Technical Service Bulletin

Subject: Aerials Solenoid Coil

Applies To: Certain 2019, 2020 and 2021 Rosenbauer Aerials with Commander chassis installed with a vendor part number of 6030-0000-00.

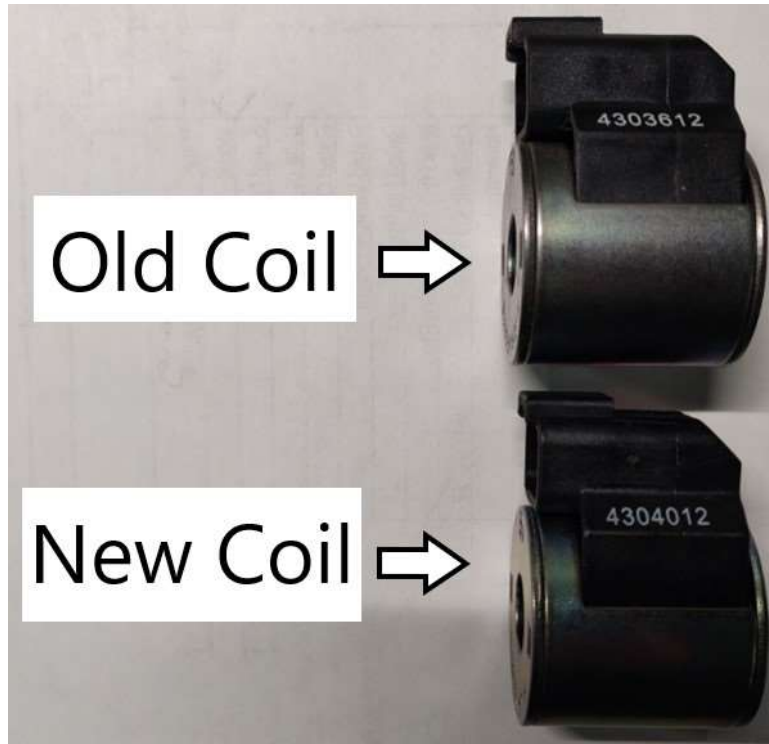
Condition: V-MUX input pin may fail due to a flyback voltage spike from an unsuppressed solenoid coil installed on a hydraulic manifold for the aerial. The V-MUX input pin calls for engine high-idle at the request from the aerial. Failure mode is that engine will not go to high-idle at the request of the aerial. Aerial PTO hydraulic pump will continue to output full system pressure and aerial will still function. Aerial may run slower due to lower engine speed.

2) Unplug 2-pin Deutsch connector and remove 3/4" nut on top of coil (see picture below).

- 3) Replace old coil with new coil.
- 4) Reinstall nut and reconnect 2-pin connector.
- 5) Test operation before and after installation for high idle function. Contact Rosenbauer Warranty and Customer Service if problems.
- 6) Once complete, install decal in officer kick plate with TSB-042121 and today's date written on it.

Old coil (unsuppressed) marked with part number 4303612.

New coil (suppressed) marked with part number 4304012.
